**SITE ISSUE PROPOSED REPAIRS TO THE TIMBER FRAME**

**FOLLOWING REMOVAL OF CEMENT RENDER**

The Limes, Rectory Road, Bacton, Stowmarket, IP14 4LE

Dwg 225/RR05

ELEVATIONS 1.100

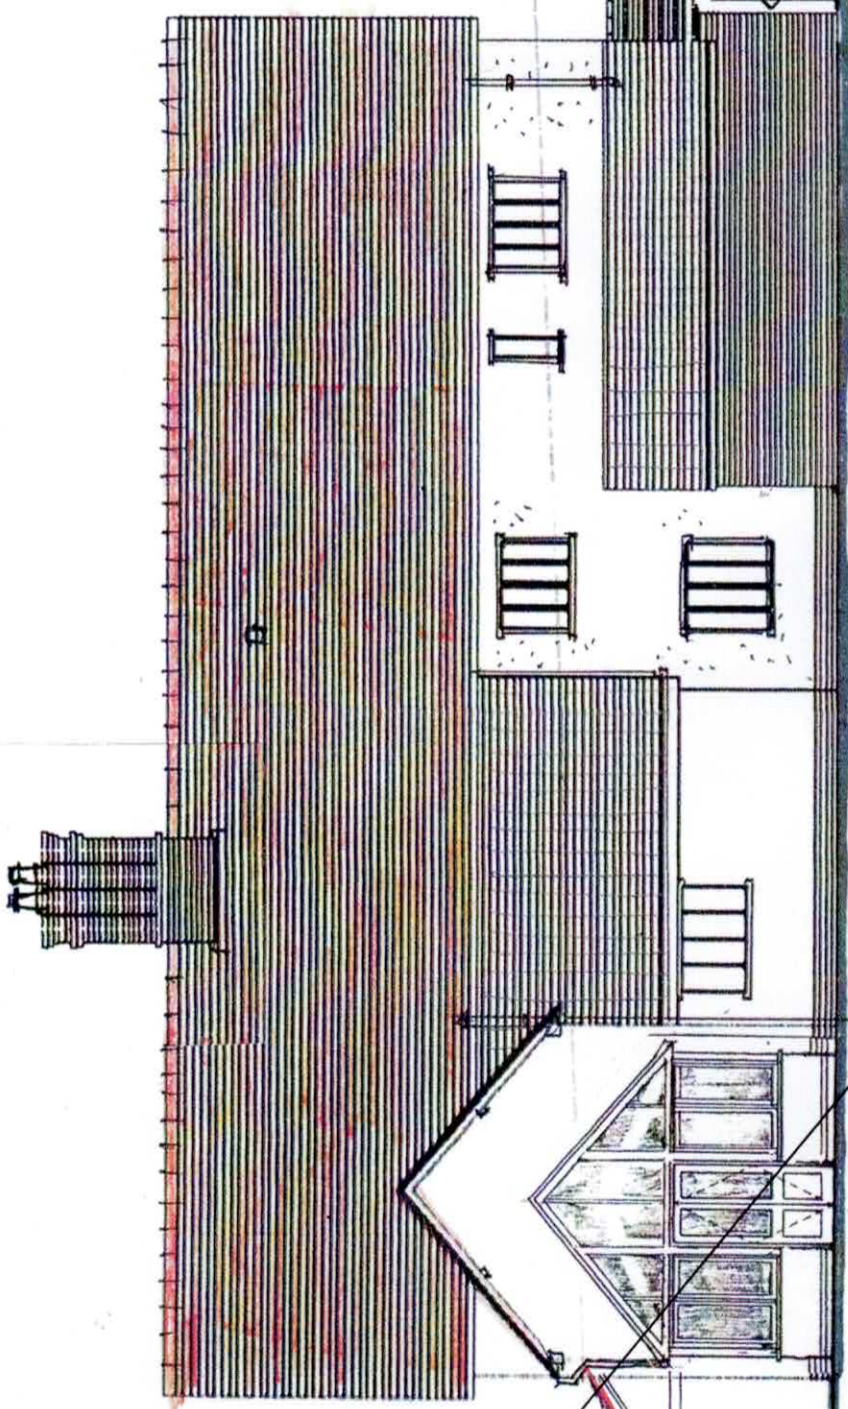
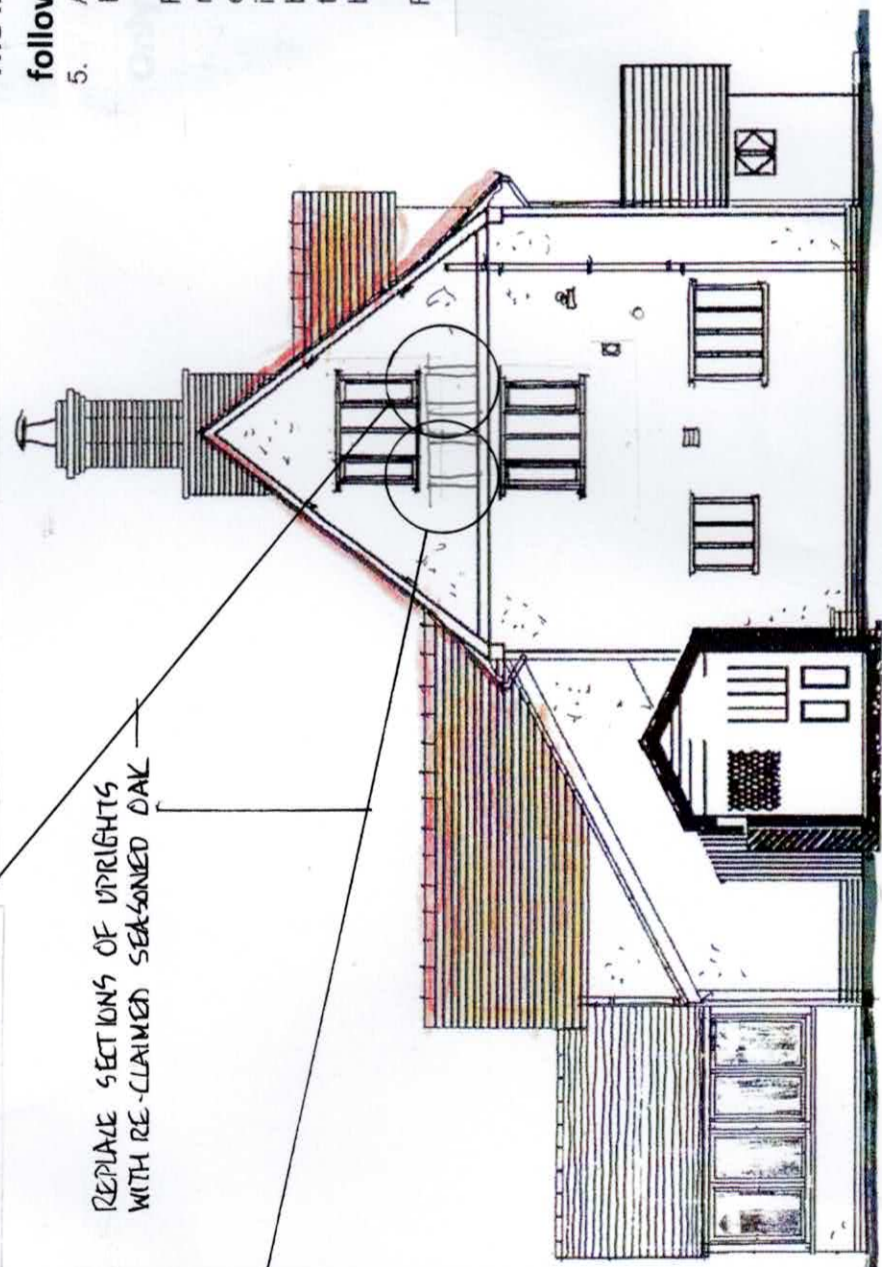
MINERAL WOOL INSULATION REPLACED WITH SHEEPS WOOL INSULATION

REPLACE SECTIONS OF UPRIGHTS WITH RE-CLAIMED SEASONED OAK
